DRAWN BY / REVISION	DATE	NO.
DM AMENDED FOR PLANNING AND LISTED BUILDING APPLICATION	16/10/17	D
DM ALTER REAR ELEVATION TO TAKE INTO ACCOUNT NEIGHBOURS CONCERNS.	8/7/16	C
DM CORRECT PARTY WALL	15/2/16	B
DM FOR CLIENT APPROVAL	29/1/16	A

ROOF PLAN EXISTING & PROPOSED
SHEET NO. **125** REVISION. **D**

33 FITZROY SQUARE LONDON W1T 6EU
JOB NO. **262**

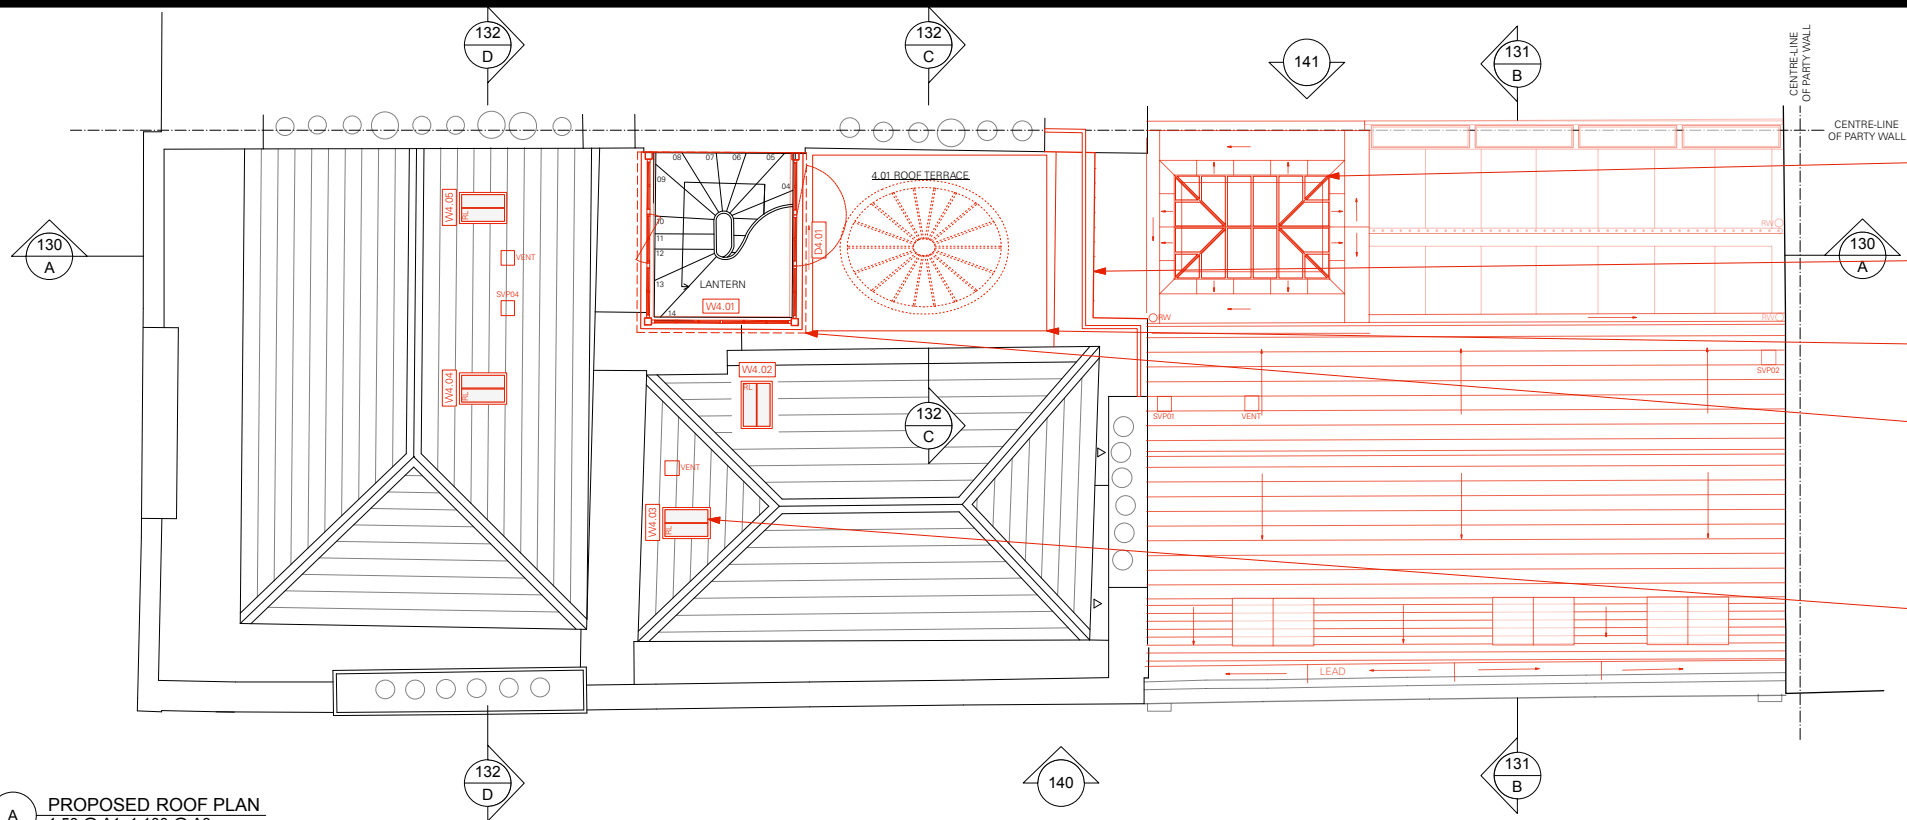
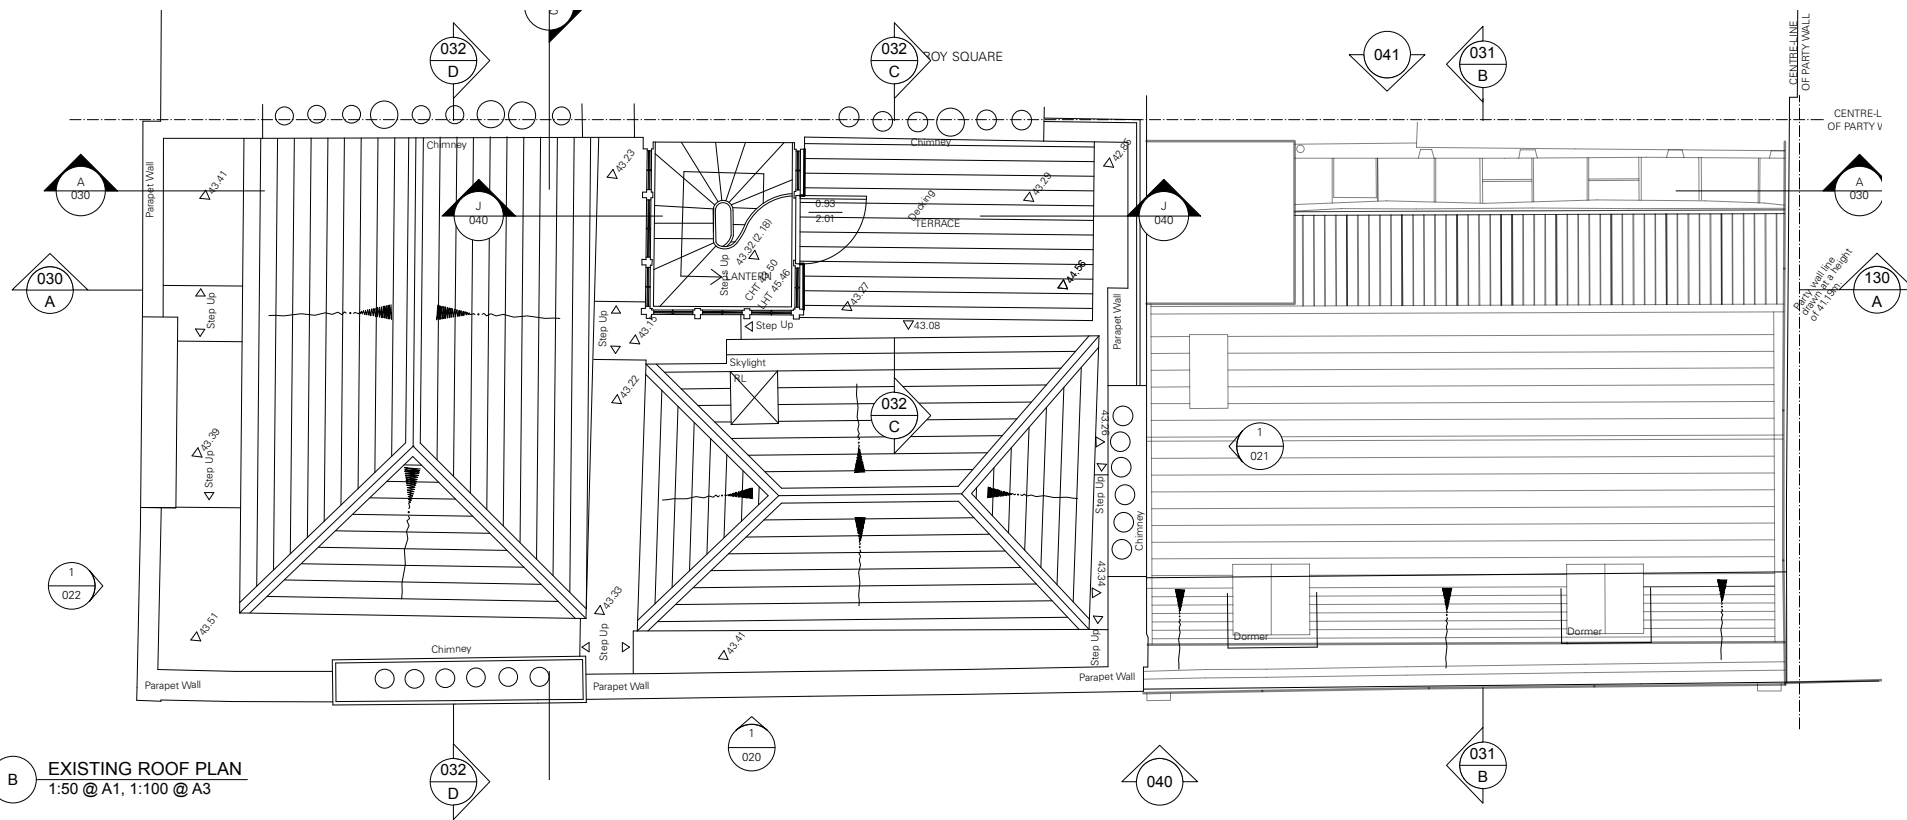
PROPOSED CHANGES FROM PREVIOUS APPROVAL.

- ROOFLIGHT AMENDED TO BE MORE IN KEEPING WITH TRADITIONAL STYLE AND WINDOW FENESTRATION.
- STAIRWELL WALL TAKEN BACK TO ORIGINAL BUILDING LINE.
- NEW WALK-ON GLASS TERRACE TO REPLACE TIMBER BOARDED TERRACE TO ENABLE LIGHT TO NEW OCLUS ROOFLIGHT BELOW.
- REPLACE TIMBER, GLASS & LEAD BELVEDERE WITH STEEL AND GLASS BELVEDERE TO MATCH OTHER ADDITIONAL FENESTRATION.
- 4NO. CONSERVATION ROOFLIGHTS ON NON-STREET SIDE OF PITCHED ROOF.
